Burlington Design Advisory Board

DESIGN ADVISORY BOARD Tuesday January 12, 2021 3:00 PM REMOTE MEETING

- 1. 21-0583CA; 52 Institute Road (RCO, Ward 4N) Burlington School Dept.**
Expansion and renovation of Burlington High School and Technical Center.

To: The Design Advisory Board
From: Mary O'Neil, AICP, Principal Planner
RE: ZP21-0583CA, 52 Institute Road (BHS)
Date: January 12, 2021

L-100
ALT

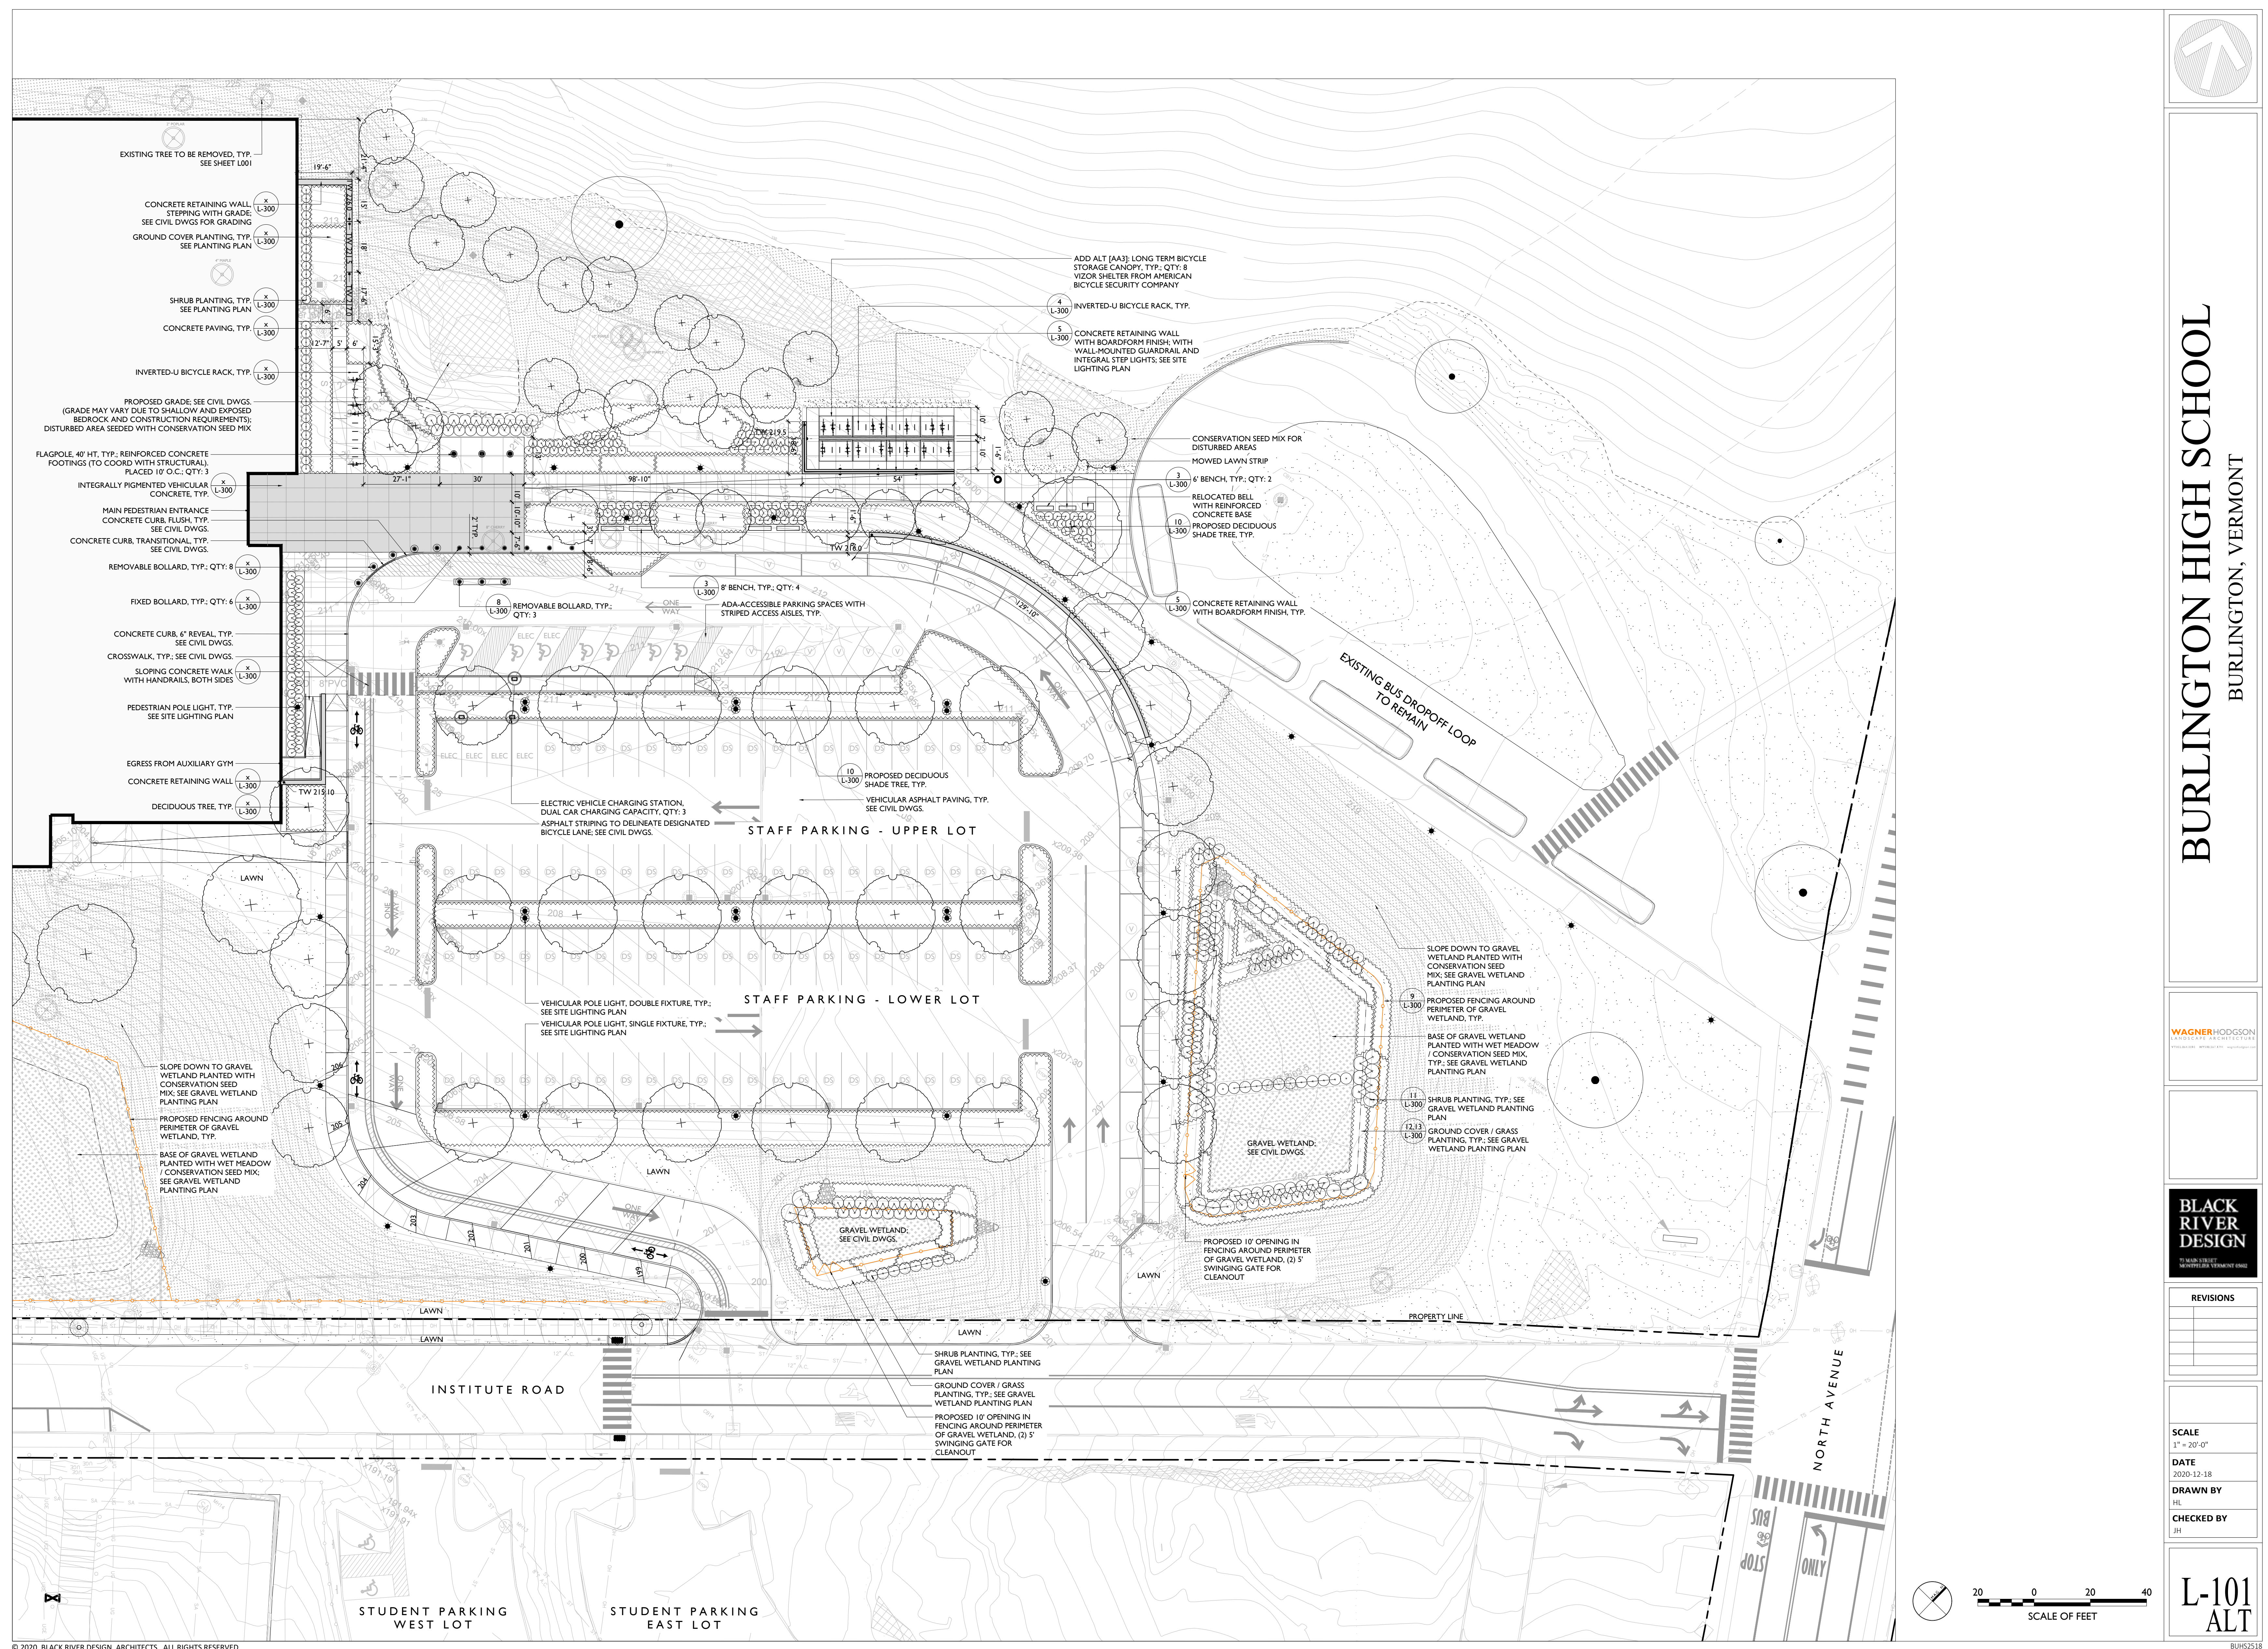
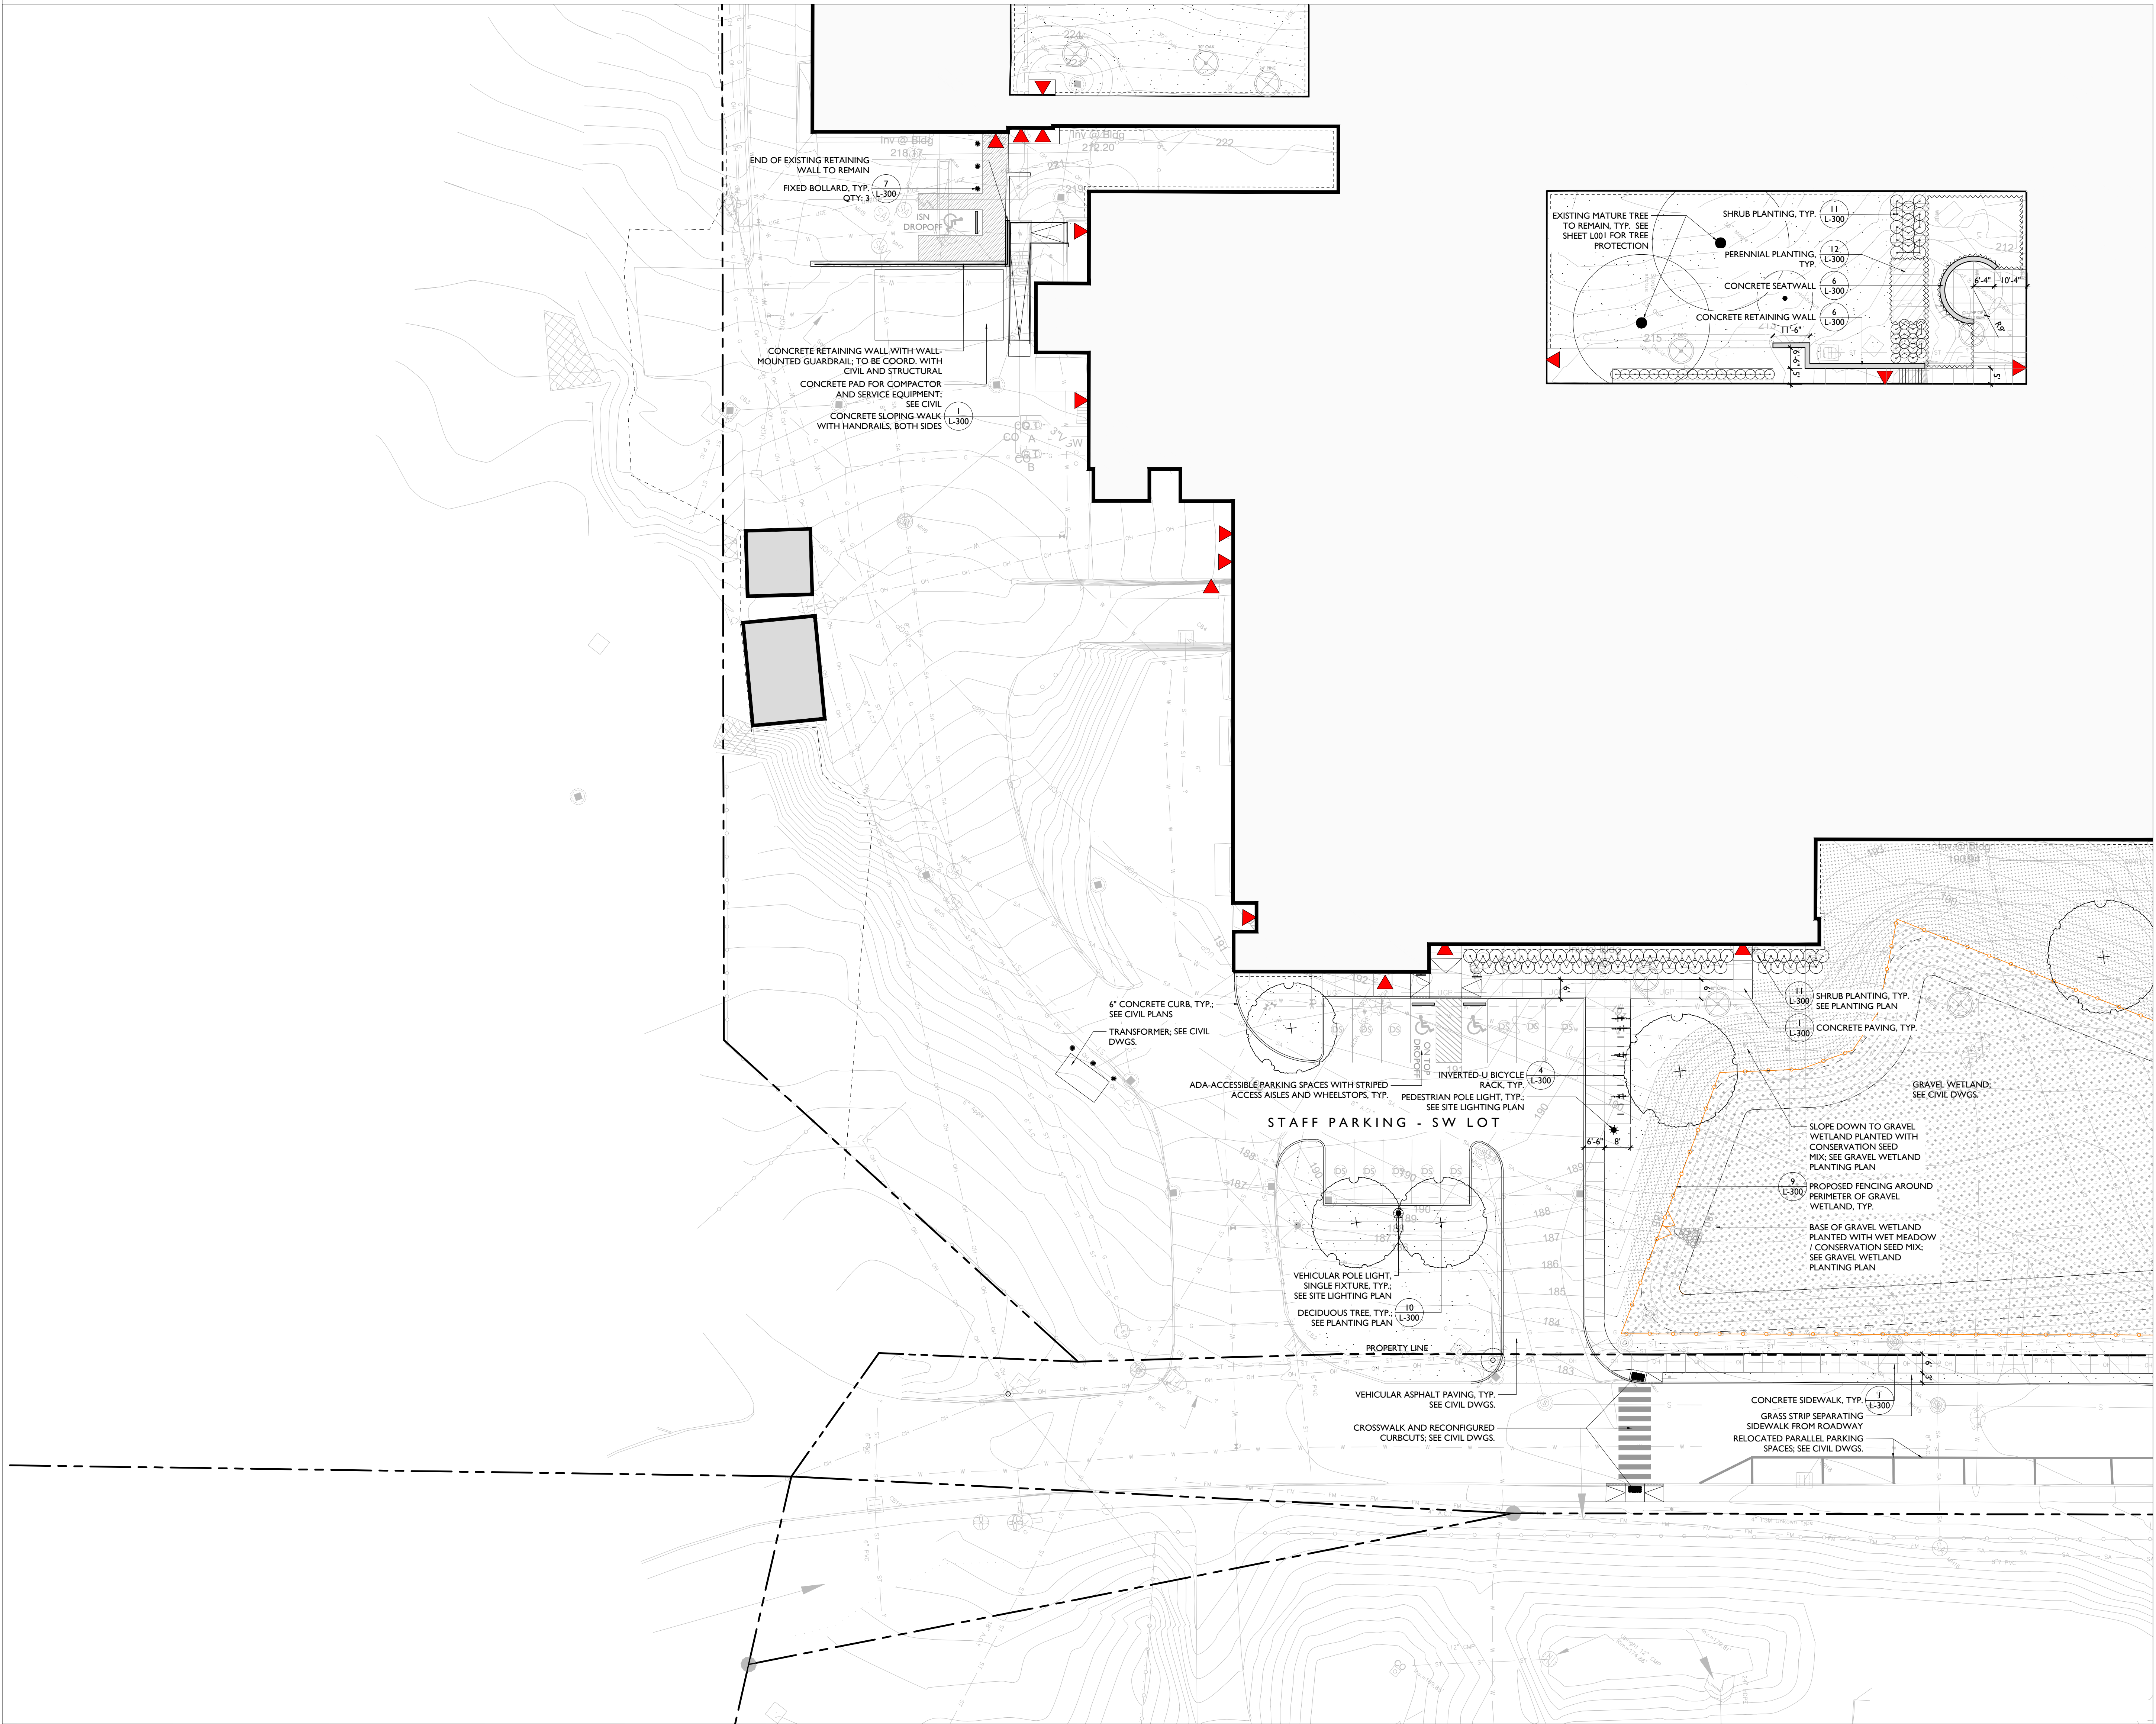
Reference is made to Plan L100 ALT, which includes the attached parking table.

The forecasted decrease in parking spaces (-6) and discussion of required parking is addressed in an overall parking management plan. See p. 68-71 in overall submission packet.
